MANDATORY RECALL

MONITORED BY THE U.S. COAST GUARD

- Circuit Breaker Mounting Location

(Figure 1)

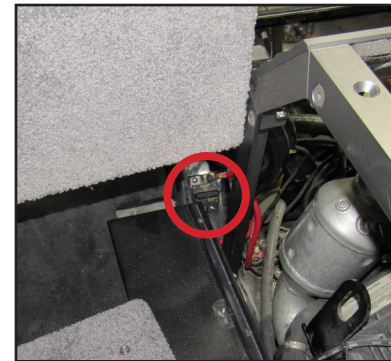
Verify that the circuit breaker is mounted properly & securely with **screws**. In most cases it can be located on the leanback panel of the port side rear seat (See **Figure 1**). Some models had the circuit breaker mounted on the inside seat base of the starboard rear seat (See **Figure 2**). If the circuit breaker cannot be found in one of these two locations, corrective action is required to locate the breaker and mount it (with screws) in a location approved by Malibu Boats, LLC. (See **Figures 1, 2, & 3**).

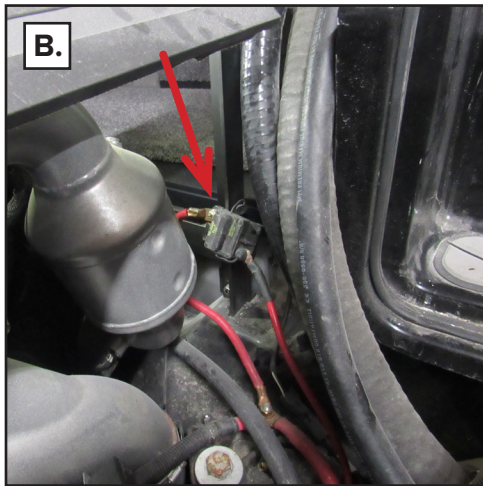
- A.** Remove the engine compartment covers and locate the circuit breaker. It should reside in the general location outlined in red.

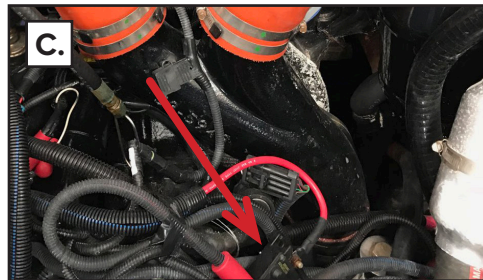
- B.** Example of improperly mounted circuit breaker (front port side of engine compartment).

- C.** Example of improperly mounted circuit breaker (front of engine compartment above V-drive).

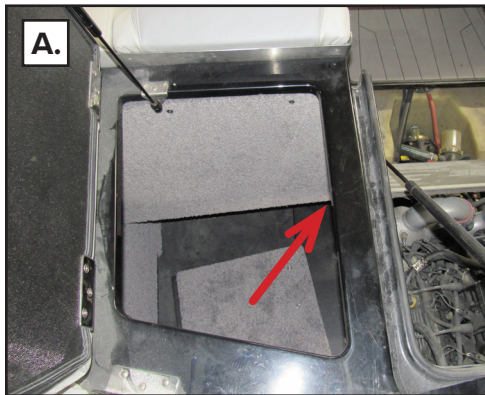
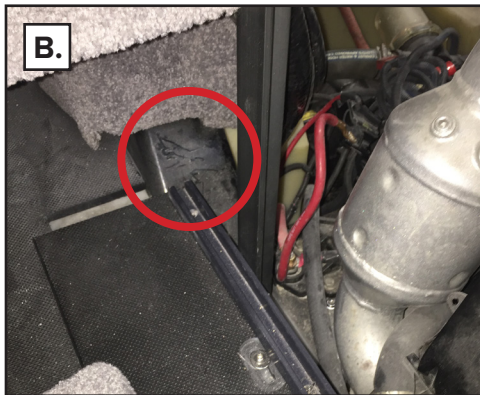
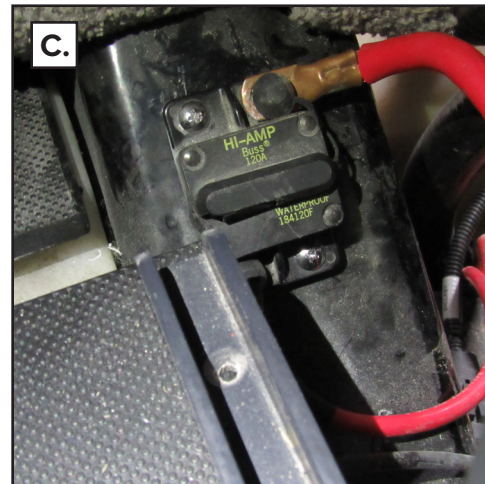
NOTE: The example below shows how the breaker can be mounted to the stringer behind the port side rear seat (front port side engine compartment).

A. The stringer can be accessed from the rear port side storage compartment.

B. This is the preferred mounting location if the length of wire is too short to mount the breaker to the leanback panel.

C. Example of properly mounted circuit breaker.

Once the circuit breaker is located, the technician may choose 1 of the 3 locations shown on the first page of this document and determine the best place to mount it depending on length of wire available and boat model.

2pc. - #10 x 1" Stainless Steel, large panhead screws
